INTERNATIONAL PRELIMINARY REPORT ON PATENTABILITY

Applicant's or agent's file reference DRCR287	FOR FURTHER ACTION		See Form PCT/IPEA/416					
International application No. PCT/KR2004/002885	International filing date(day/month/year) 09 NOVEMBER 2004 (09.11.2004)		Priority date (day/month/year) 12 NOVEMBER 2003 (12.11.2003)					
International Patent Classification (IPC								
E05F 3/06(2006.01)i								
Applicant								
SONG, Jang-Woo								
This report is the international property under Article 35 and to			nternational Preliminary Examining

PCT/KR2004/002885

[Fig.11]

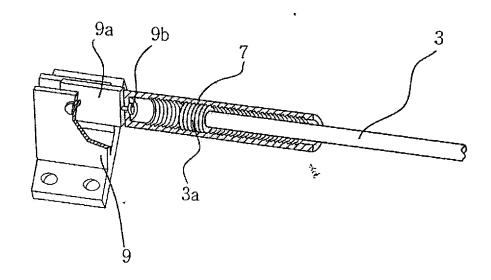
In the specification pages 6-7 (Best Mode for Carrying Out the Invention), applicant has added description about reference numerals *a subsidiary plate 9a* and *subsidiary pin 9b* which are disclosed in Fig. 11. See Replacement Drawing Sheet.

In the drawing, a subsidiary plate 9a and subsidiary pin 9b which are disclosed on Fig. 11 of the original application but not properly named. A Replacement Sheet is attached hereto.
